Plan Commission

Special Meeting

Agenda

Monday, April 3, 2017	7:00 PM	De Pere City Hall Council Chambers
------------------------------	----------------	---

PROJECT NO.
G-517
SHEET NO.
1 of 5
DRAWING NO.
S-2741

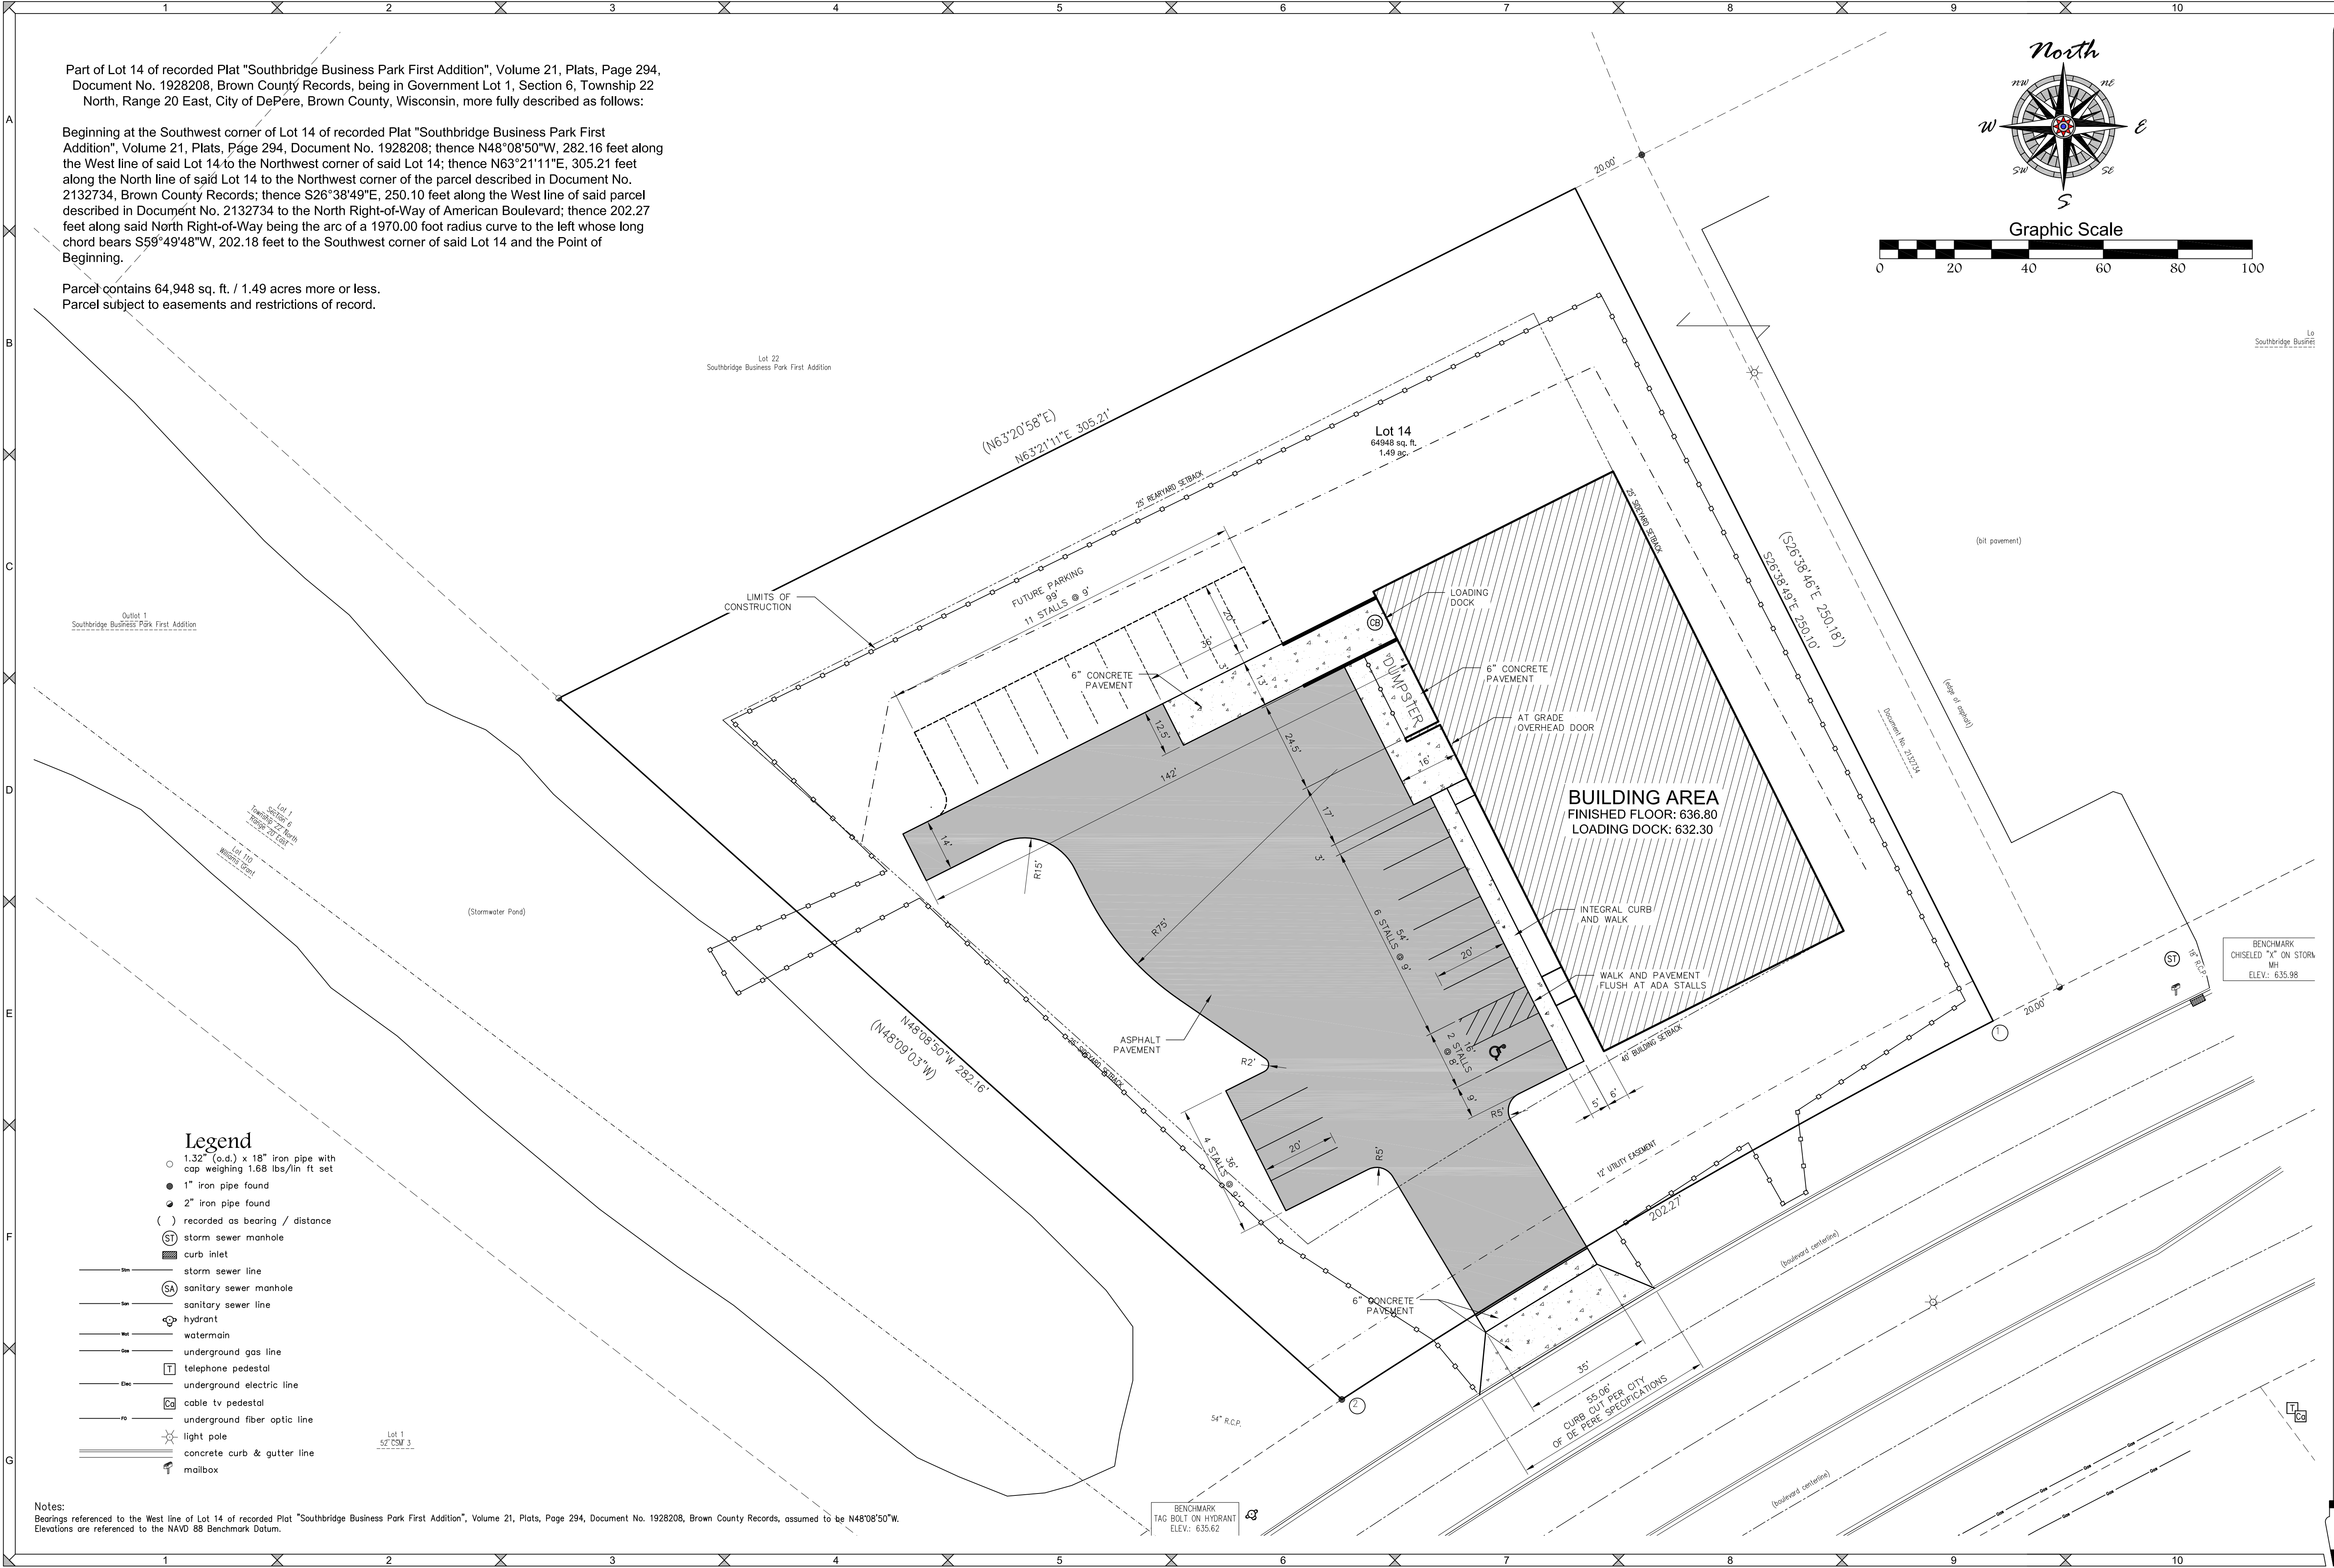
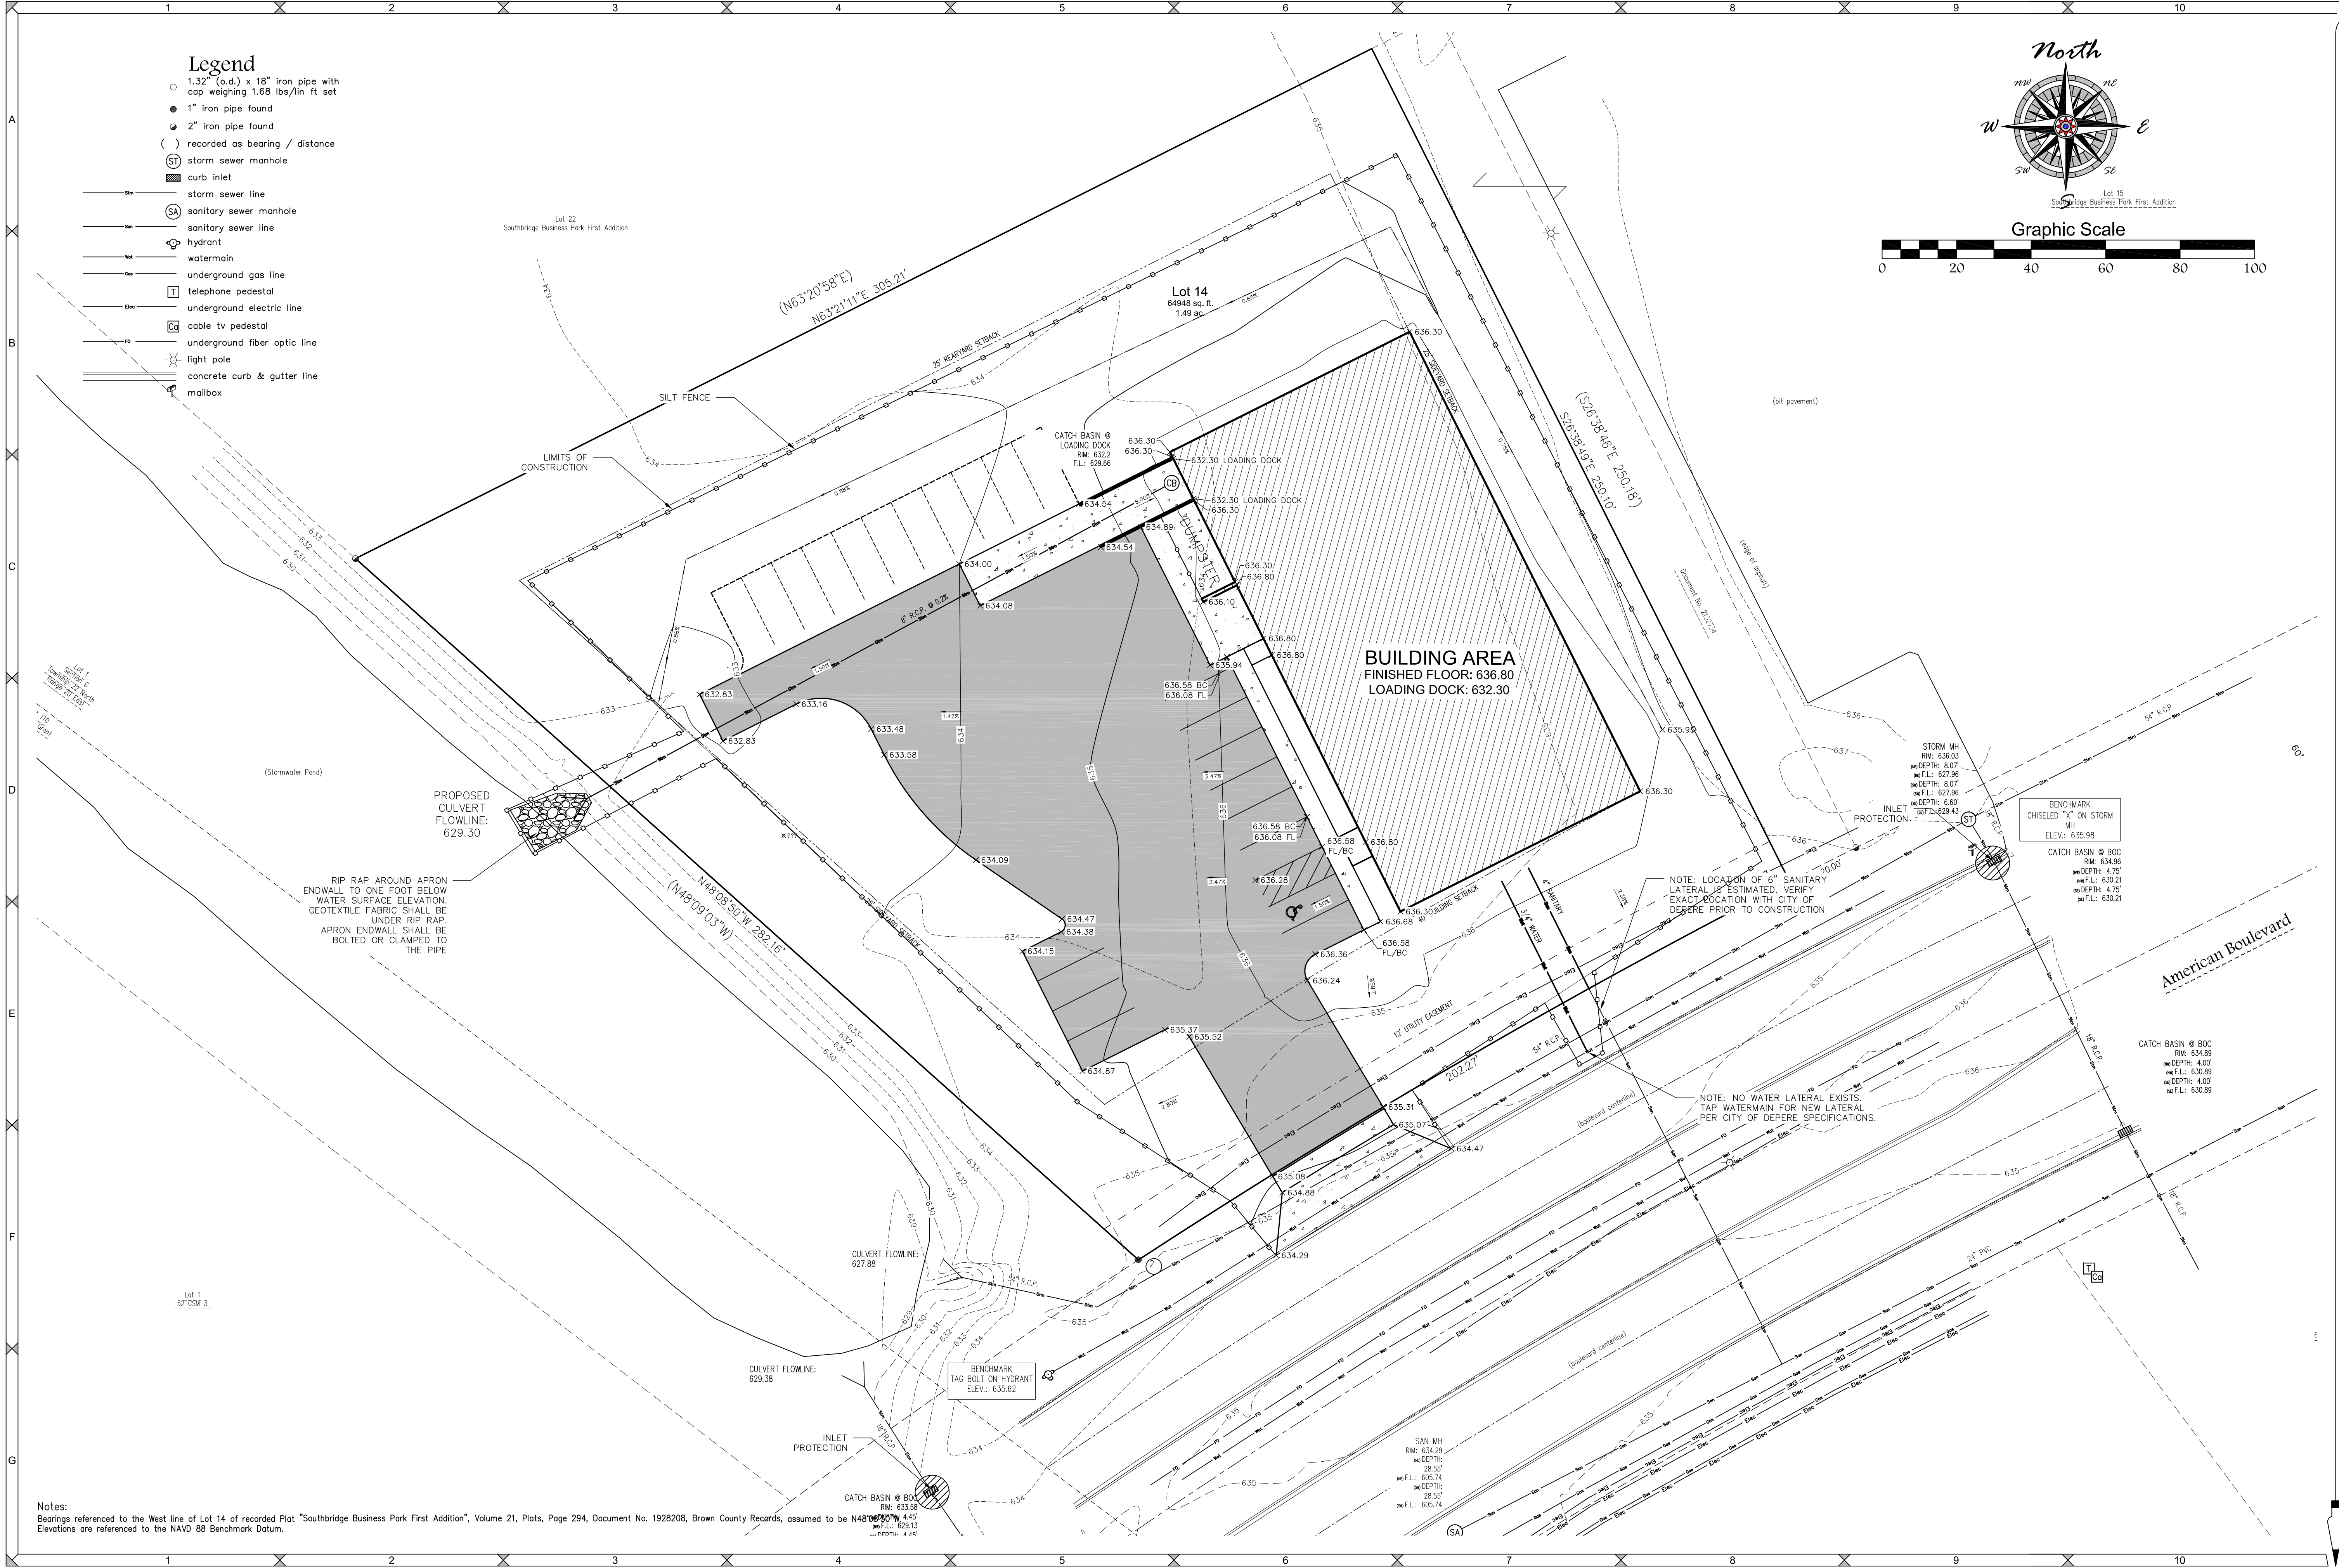
1. Cover sheet: List full address and parcel ID on cover sheet for the proposed development.
2. Sheet 1/5: Concrete driveway and sidewalk section (all concrete in the right-of-way needs to be 8" concrete per City standards.

3. Sheet 1/5: All striping for parking must be 4-inch
4. Sheet 1/5: The last four stalls (to the east) would be infeasible with the loading dock. Potential to park vehicles in.

5. Sheet 1/5: please provide size and depth for integral curb and walk.
6. Sheet 2/5: Excavation permit needs to be approved by De Pere Engineering prior to installation of water and sanitary sewer laterals. Contact 920-339-4060 for permitting needs.

- Sheet 1/5: City would recommend loading docks and dumpster collection area to be 8-inch concrete for truck loading.
- Sheet 5/5: Bollard & Dumpster Enclosure Detail is duplicated.
- Consider narrowing the curbcut and driveline width as the width appears to be excessive.
